# UNITED STATES PATENT AND TRADEMARK OFFICE

<b>Office Action Summary</b>	<b>Application No.</b> 10/659,303	<b>Applicant(s)</b> SUZUKI ET AL.	
	<b>Examiner</b> Grace SC Doe	<b>Art Unit</b> 3732

### **DETAILED ACTION**

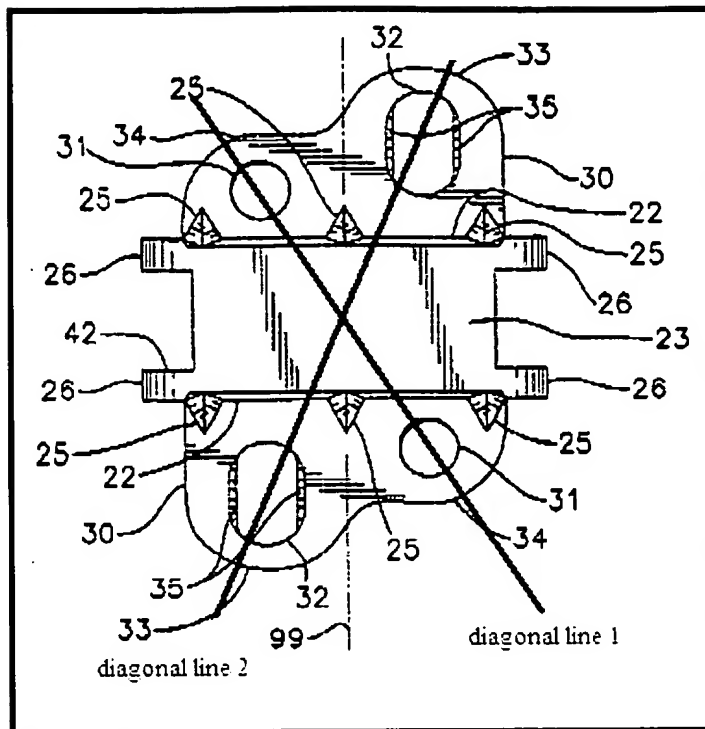
10. In response to Applicant's argument that Scharf fails to disclose at least one spike extending continuously from the main body portion, the main body may be defined as including the plate 30 and spacer 20. Therefore Scharf clearly shows that the spikes are continuously attached to the spacer, 20, and plate, 30, through part 22 (See figure 1). The spacing between plate 30 and spike 25 is of no consequence since the main body may be defined as including parts 22 and 33. Applicant further argues that only the plate 30 has diagonal lines. Examiner would like to point out that any object may be geometrically sectioned by diagonal lines. It is possible to superimpose a set of diagonal lines that extend through the plate, 30, and spacer, 20. Figure 3 clearly shows a main body, defined by a plate, 30, and spacer, 20, wherein the spikes, 25, are located near a pair of diagonal lines (See below figure).
